Sandsend visitor car park (NYM/2020/1018/FL) Discharge of Conditions 9 and 11 and revisions to plans previously approved (NYM/2022/0155) pursuant to Condition 7 (Planning Portal Ref: PP-11283579)

**Proposed Car Park,
The Mulgrave Estate, Land off the A174
Sandsend**

Stage 2 Road Safety Audit

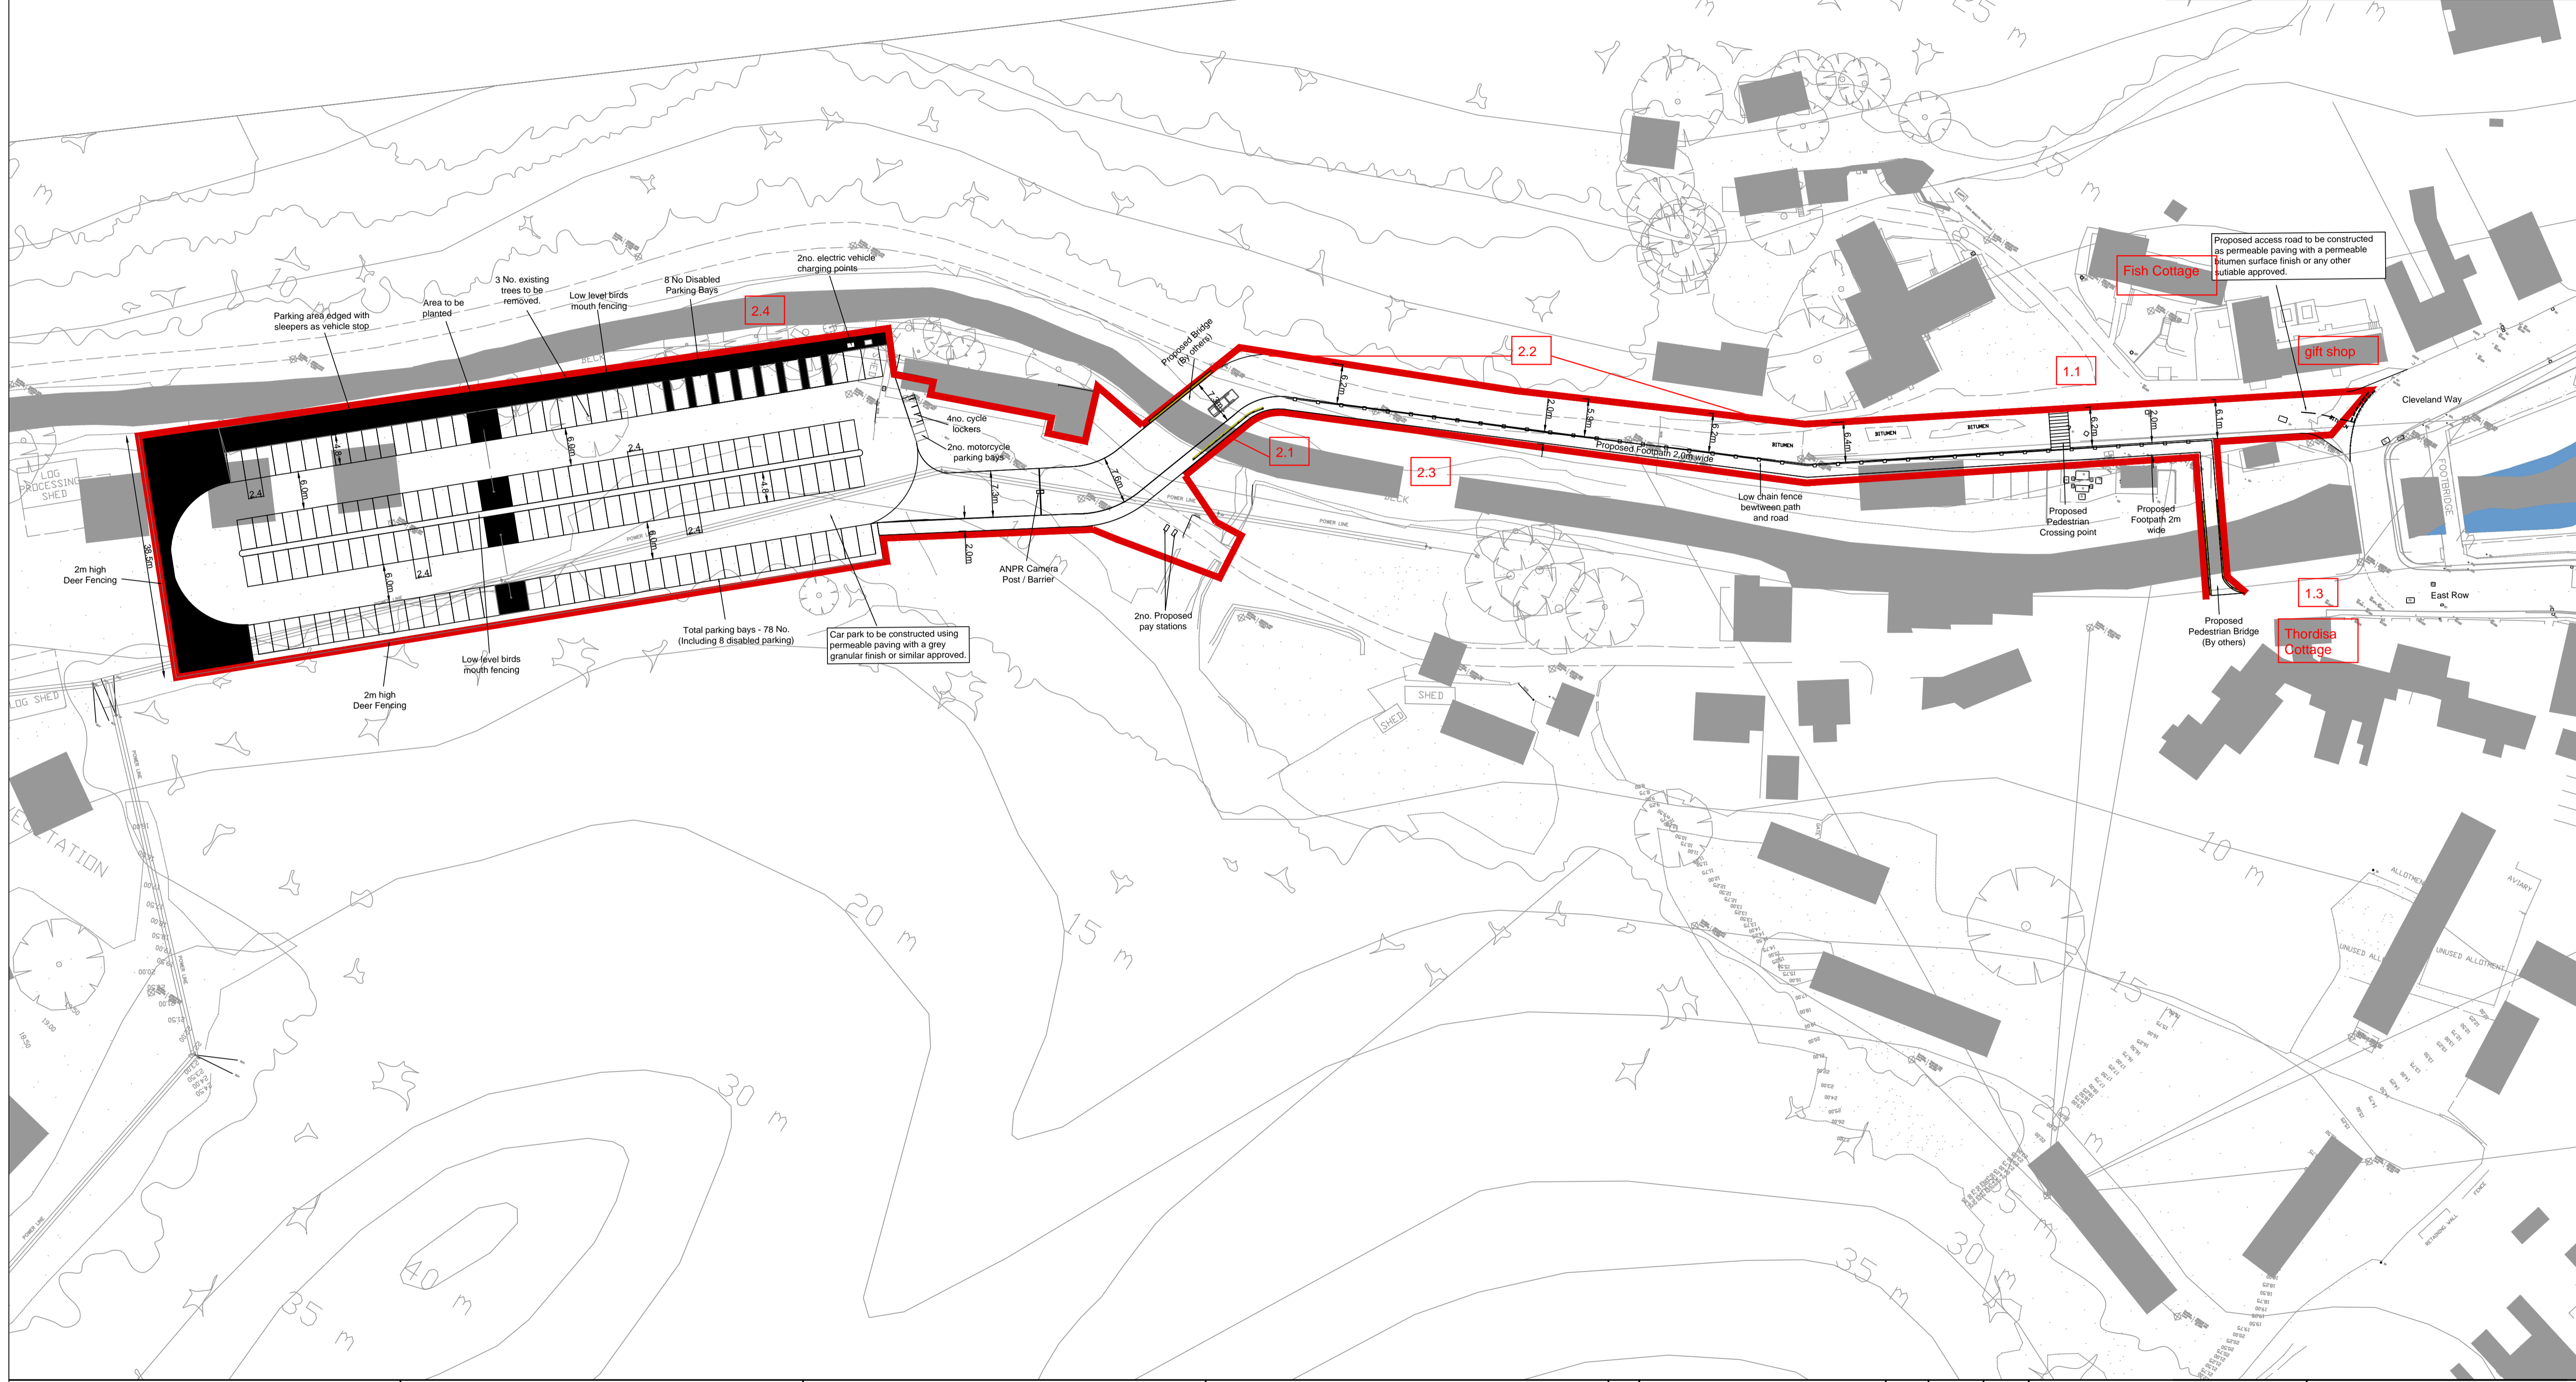
From drawing 300630-1100-001 it appears that a bullnose dropped kerb is proposed on the northern side of the proposed access road adjacent to the Fish Cottage and gift shop which also incorporates a pedestrian crossing point, presumably for pedestrian access to the Fish Cottage and gift shop. Furthermore, the area between the edge of the proposed access road and the gift shop is particularly uneven with a gravel surface, a drainage grip and rope barriers which

prevent pedestrians using the area. Parking on the southern side is inhibited by a low chain fence and kerb up to the proposed footbridge. No details of any highway works or surface treatment on the northern side of the access road are shown on the drawings or how parking might be retained. If parking takes place on an ad hoc basis this could lead to pedestrians walking in the carriageway to access the Fish Cottage and gift shop and result in conflict with vehicles that are behind them exiting from the car park.

Stage 2 Recommendation: If car parking (for the gift shop and Fish Cottage) is to be retained, formalise the parking arrangements and its management and provide pedestrian facilities to access the shops and other buildings on the northern side of the new access road, providing dropped kerbs and tactile paving where appropriate so pedestrians can cross the proposed access road to the footbridge.

Summary: Drawing 300630-1100-001 appears to show a bridge parapet / barrier on the southernmost side of the bridge which is within the footway width (2m) but no dimensions are shown for the proposed clear width of footway between the parapet and kerb line. Inadequate pedestrian footway width could lead to conflict between pedestrians and vehicles if they step into the carriageway to pass opposing pedestrians or pass family groups utilising the full width of the reduced footway width.

Recommendation: Provide an appropriate footway width passed the parapet/ barrier.

Summary: Drawing 300630-1100-001 shows that the northernmost edge of the proposed access road is in the order of 3m from the edge of the existing surfaced access track. The land on the northern side of the existing access track rises steeply from the edge of the track and no details of how the land will be regraded or retained are shown nor how surface water run-off from the land on to the carriageway will be intercepted to prevent silt and other soil debris being washed on to the carriageway surface. Furthermore, there are several individual mature trees that are likely to be effected by the excavations for the new access road. Given that permeable surfacing is proposed and the longitudinal and cross sectional gradients are fairly flat a build up of silt and debris or water on the carriageway surface could lead to reduced drainage performance or skid resistance and result in vehicle loss of control / skidding type incidents. Furthermore, since permeable surfacing is proposed there are no gullies proposed against the proposed kerb line which would act so as to stop surface water flowing off the carriageway and if surface permeability is impaired over time, water could

pond at low spots in the vertical alignment leading to vehicle loss of control / skidding type incidents.

Recommendation: Provide an appropriate cross sectional detail on the northern most side of the access road to minimise surface water run-off from the land on to the carriageway and hence silt / soil and other debris being washed on to the carriageway surface.

Summary: Drawing 300630-1100-001 shows the provision of a low chain fence between the footway and kerb line which is within the footway width (2m). No dimensions are shown for the proposed offset from the kerb for either clearance to vehicles and the remaining clear width of footway. The purpose of the low chain fence is not clear but it would inhibit vehicles parking part on the footway obstructing pedestrians. Inadequate pedestrian footway width could lead to conflict between pedestrians travelling in opposing directions on the footway or to pass family groups utilising the full width of the footway and in this case they could step off the back of footway. Alternatively, pedestrians could walk in the carriageway at busy times, on the wrong side of the low chain fence, in conflict with vehicles since they could not easily step back onto the footway. Furthermore, if pedestrians step off the back of footway there is a level difference between the footway and East Row Beck, which is just to the south. The design response to item 1.5 suggests that a 1m high bird-mouth fence would be provided along the top of embankment to prevent falling from height.

Recommendation: Provide an appropriate footway width between the low chain fence and back of footway and also between the fence and vehicles. This would be in conjunction with fence along the top of the embankment / back of footway.

Summary: Drawing 300630-1100-001 shows the provision of disabled parking on the northern side of the car park layout the furthest distance from the proposed footway on the southern side of the access road. There is no pedestrian route along

the eastern most edge of the car park and passed either the electric charging points or cycle parking. In this situation persons with mobility impairments or using wheelchairs from the disabled parking bays would have to share the car park aisle and cross the car park entry traffic stream to access the footway. An inadequate pedestrian route from the disabled parking to the footway and dropped kerbs could lead to conflict between pedestrians and vehicles.

Recommendation: Potentially relocate the disabled parking to the southern side of the car park layout adjacent to the proposed footway and provide dropped kerbs or provide a footway around the eastern edge of the car park or if these are not feasible provide a marked pedestrian route leading from the disabled parking to the footway and provide dropped kerbs.
